April 23, 2020

RE: Serial Letter #61
Sheboygan River and Harbor Superfund Site – EPA Review of Remedial
Action Plan for Tecumseh Falls and Maryland Avenue Sites
SME Project No. 069638.00.051.000

Date	04-09-2020
CADD	SRP
Designer	KE
Scale	1" = 50'
Project	069638.00.051
Figure No.	1

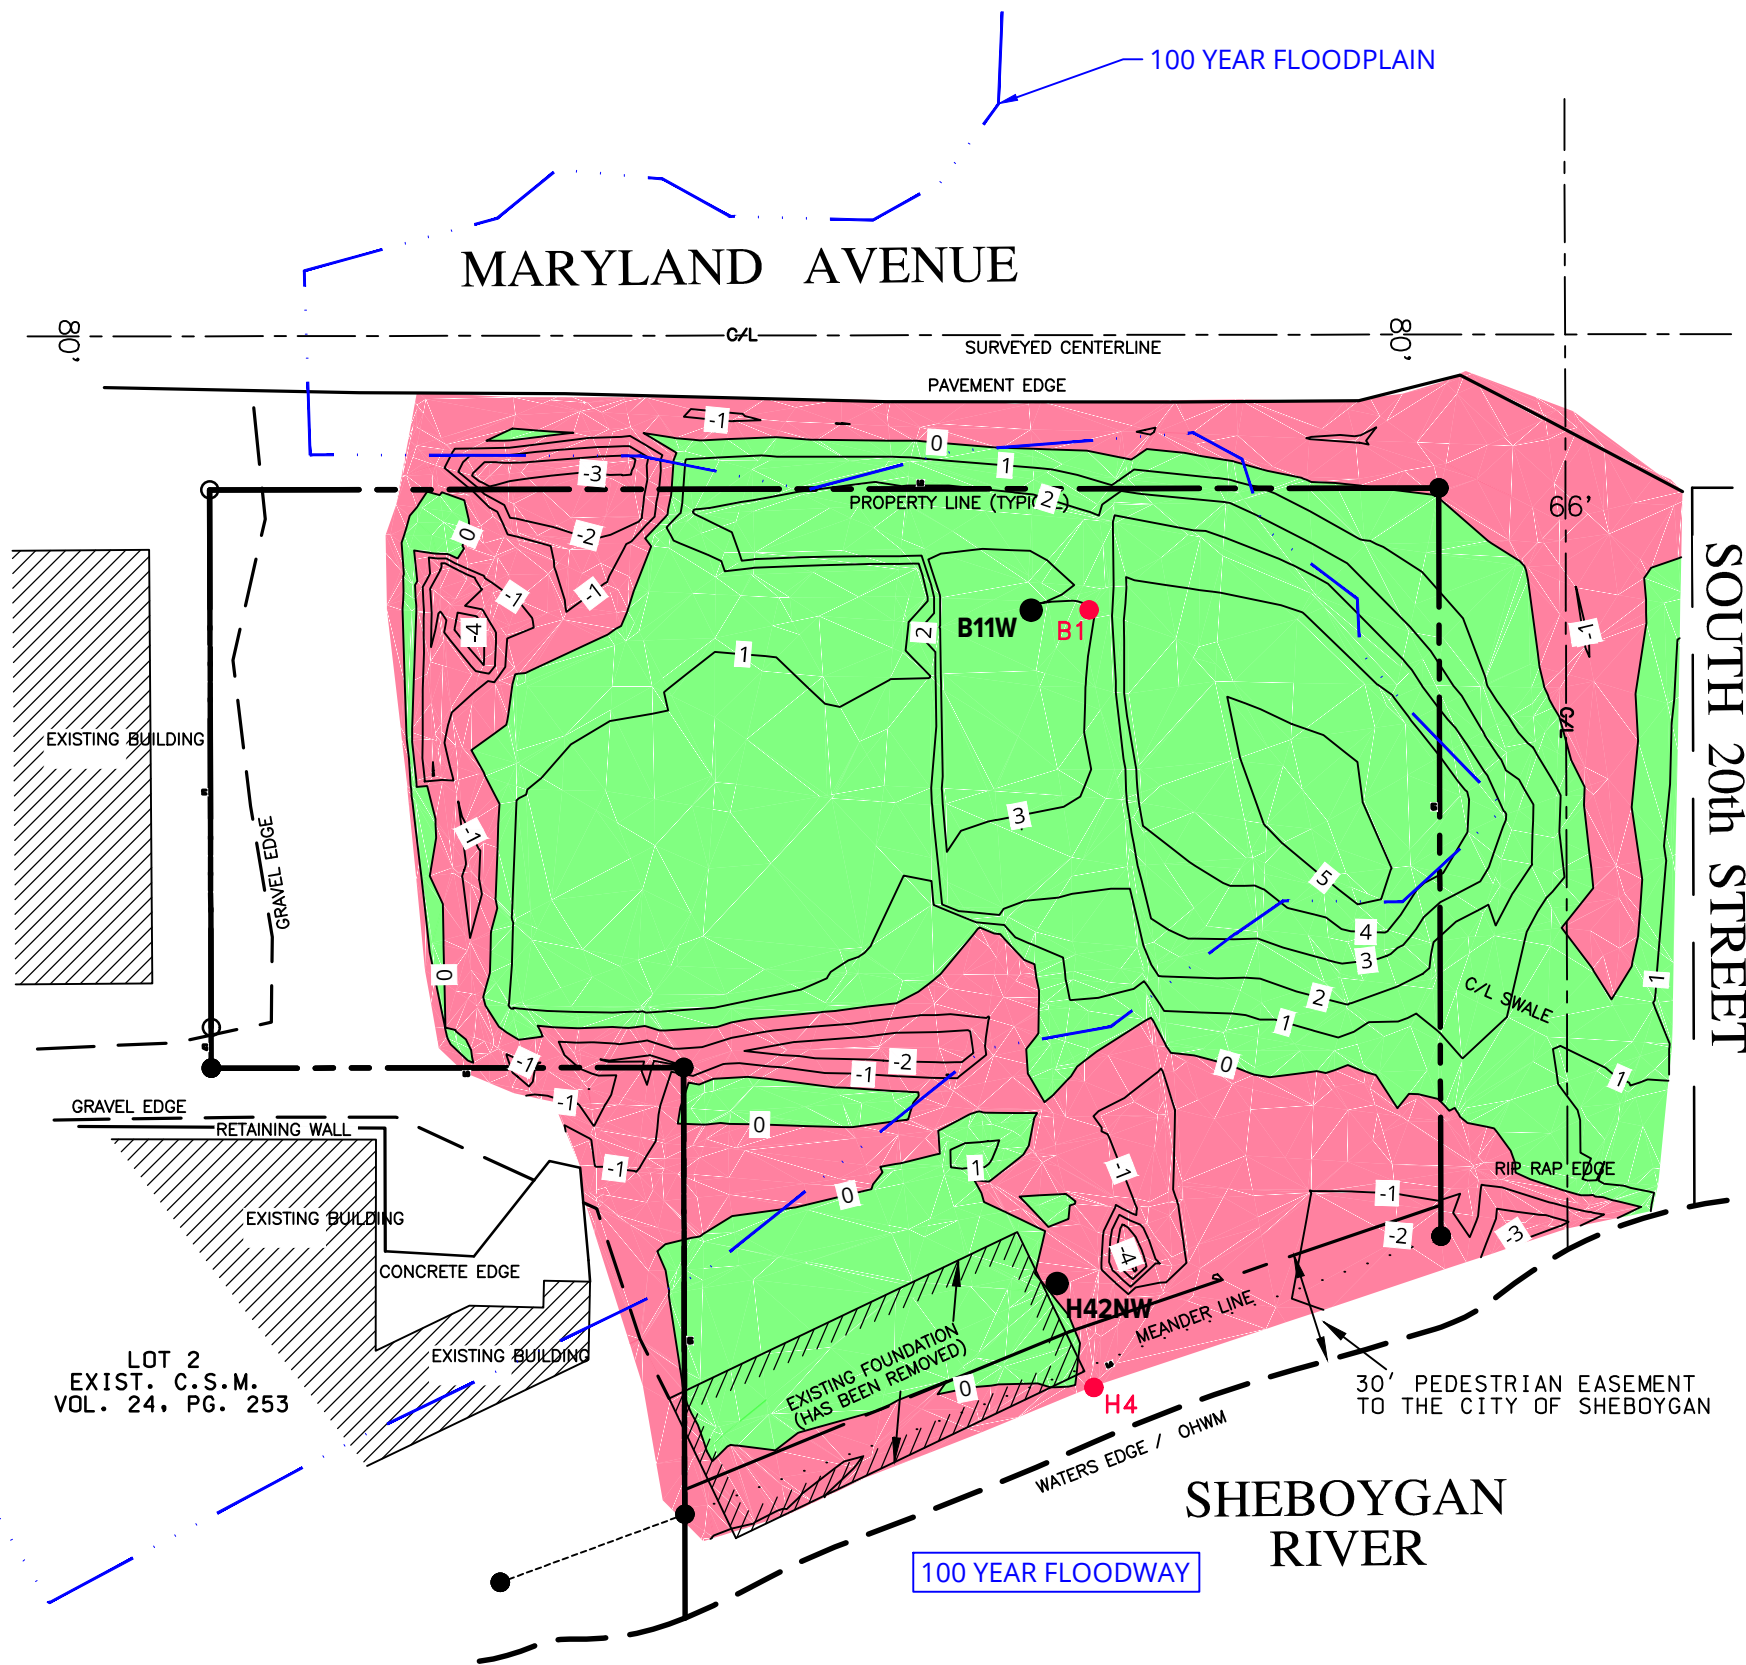
USEPA Comment 11: *Maryland Ave – Section 3.2, Sample Depth Interval data – It appears that a significant reduction in the contaminant load at the property could have been effectuated by the removal of the top 6 inches of soil. However, based on recent discussions, it seems that the property has since been filled and regraded. Please provide EPA with detailed information regarding all recent excavation, disposal, filling, and regrading actions at the property.*

SME Response: SME provided a report of the Maryland Avenue site restoration activities in Serial Letter 56 dated July 11, 2019 which I have recently forwarded to you. I believe the report provides the information you seek. Figure 1 shows the cut and fill depths compared to sample locations of concern. Of the four samples that exceeded the 10^{-6} Regional Screening Levels, the impacted soil at two locations (B1 and B11W) are now encountered at a depth to 3 to 4 feet below ground surface (bgs). The impacted soil at the two other locations was removed during grading and buried deeper at the Property. None of the PAHs that exceeded the 10^{-6} RSL exceeded the 10^{-5} RSL.
